ADDENDUM NO. 3

CITY OF MASSILLON, OHIO
WWTP UPGRADE 2000

SK-P135-002

*SLAB MOUNTED ULTRASONIC
LEVEL SENSORS*

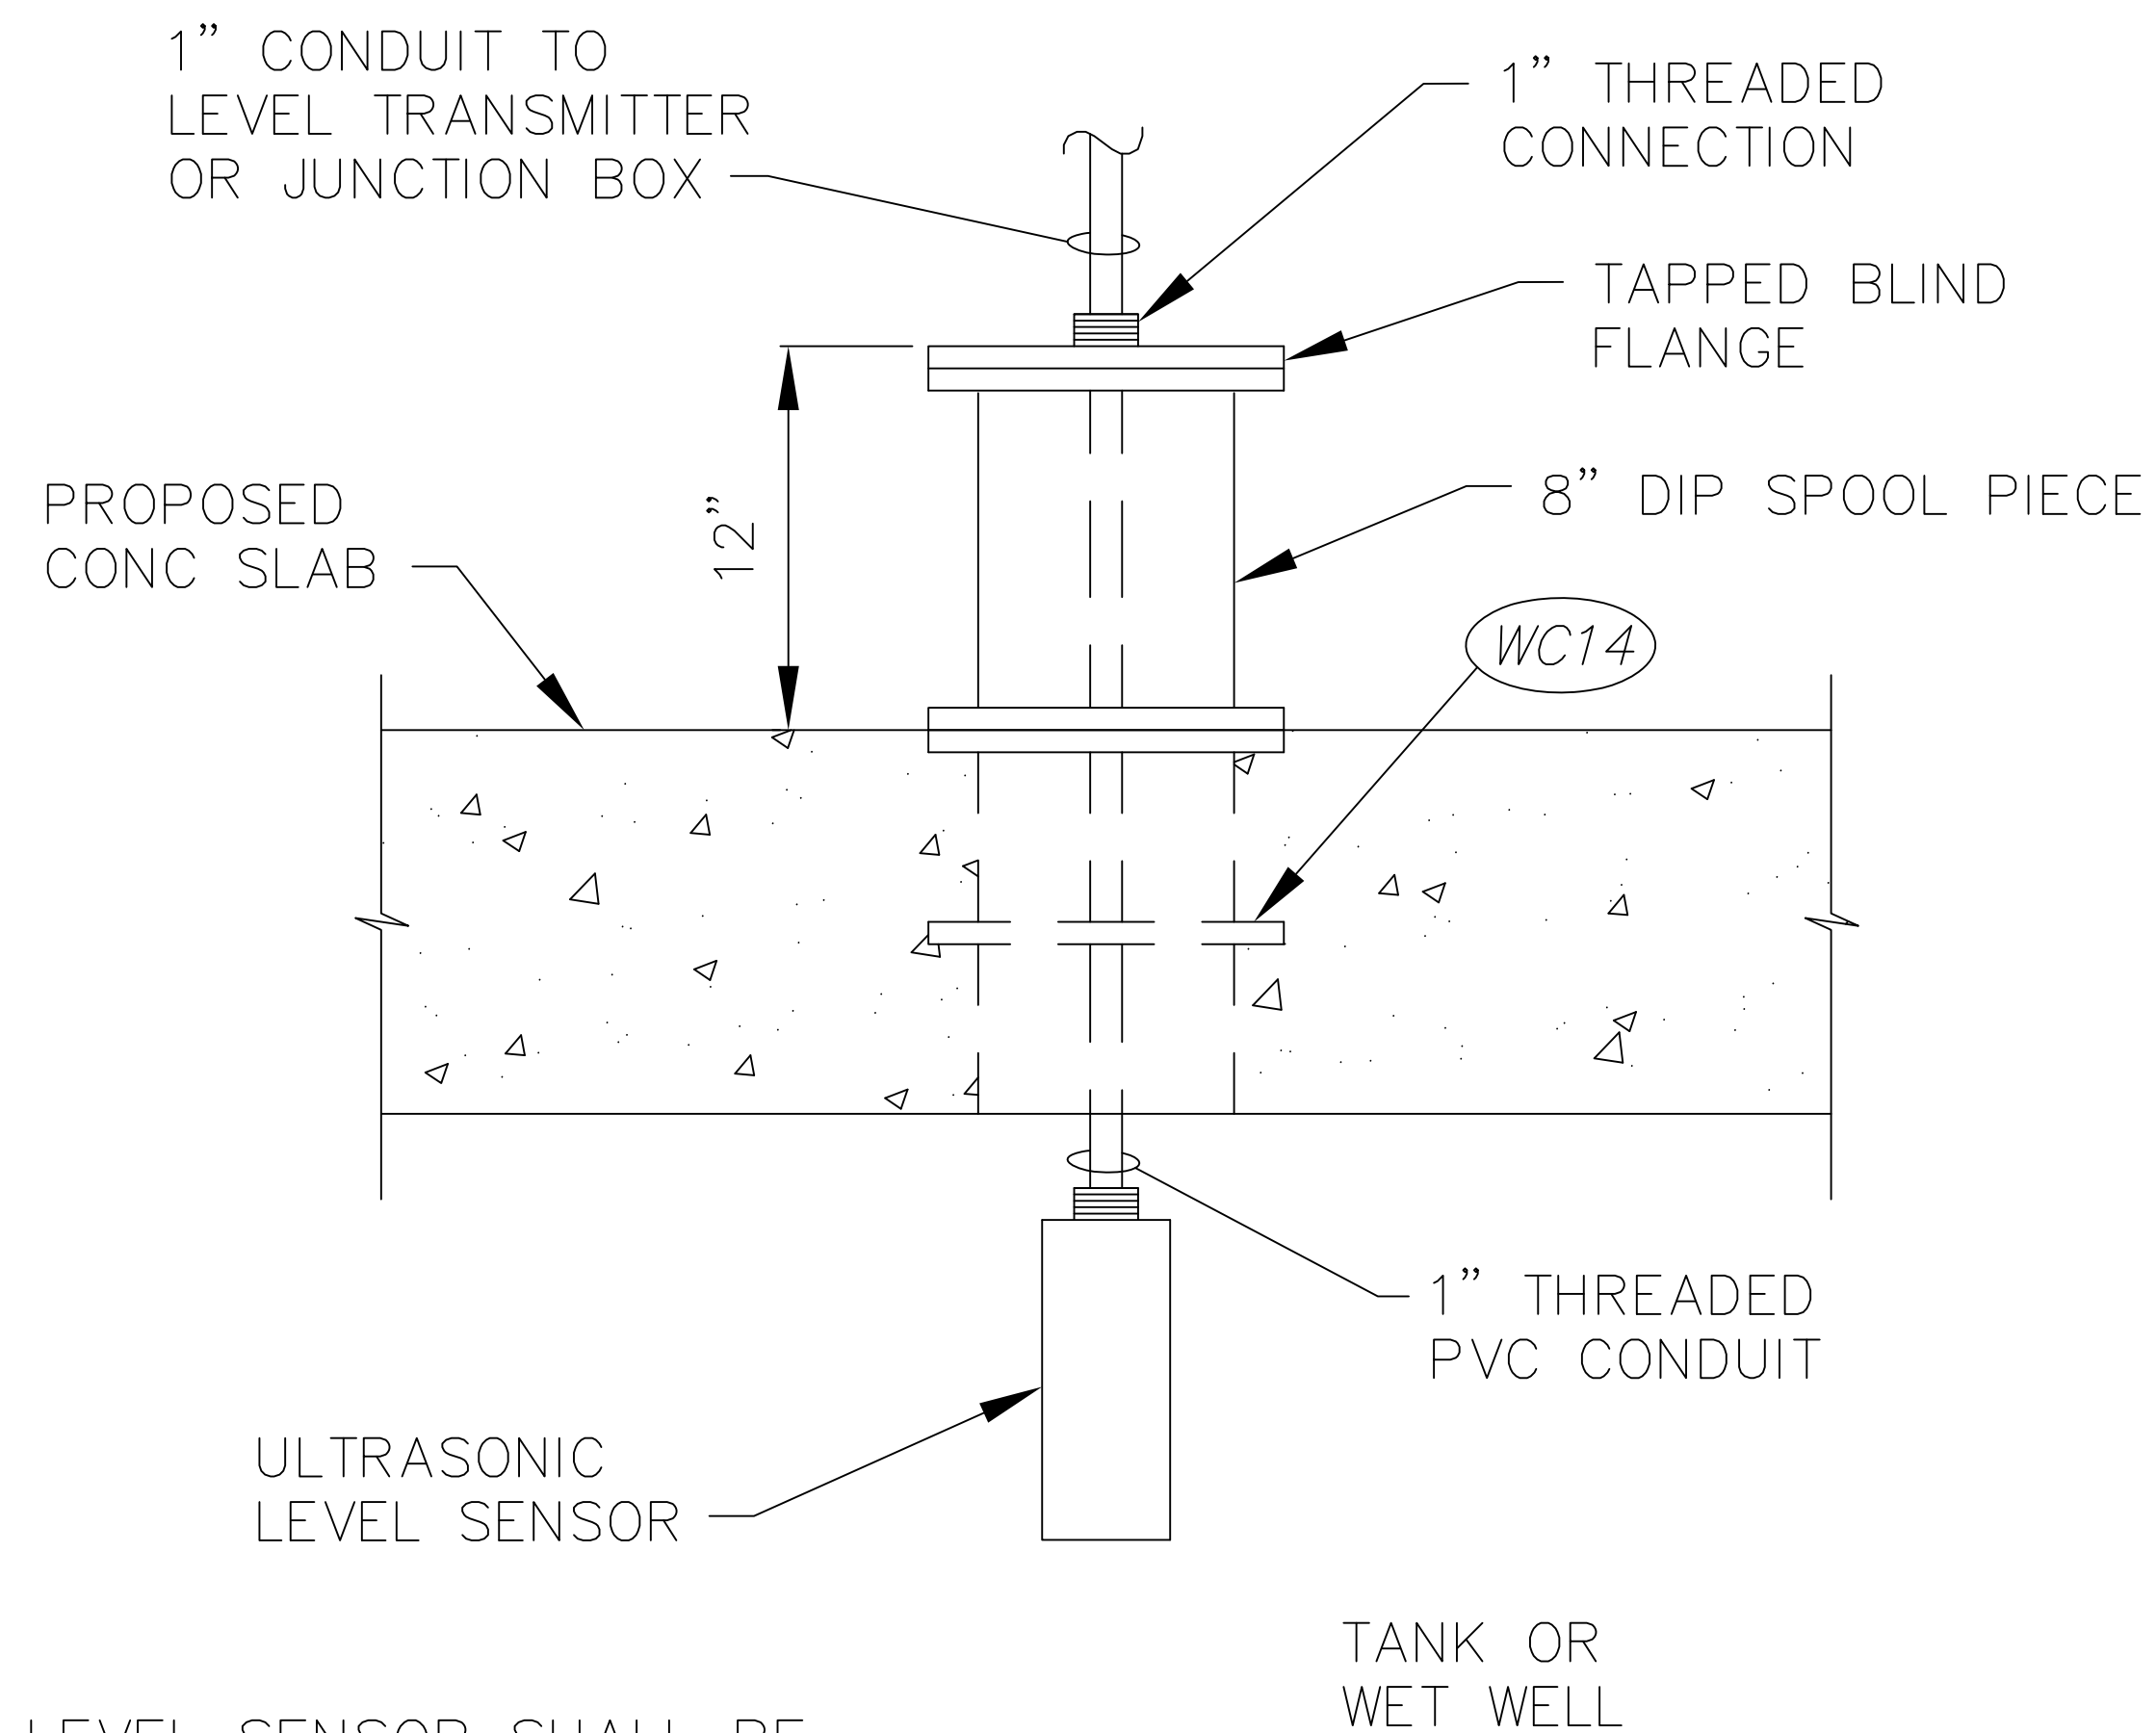
- NOTES:
1. ULTRASONIC LEVEL SENSOR SHALL BE LOCATED 24" MIN FROM ADJACENT WALLS AND EQUIPMENT OR AS OTHERWISE REQUIRED BY MANUFACTURER.
 2. PROVIDE SUFFICIENT LENGTH OF CABLE AND WIRE FOR SENSOR TO BE REMOVED WITHOUT DISCONNECTING CABLES.
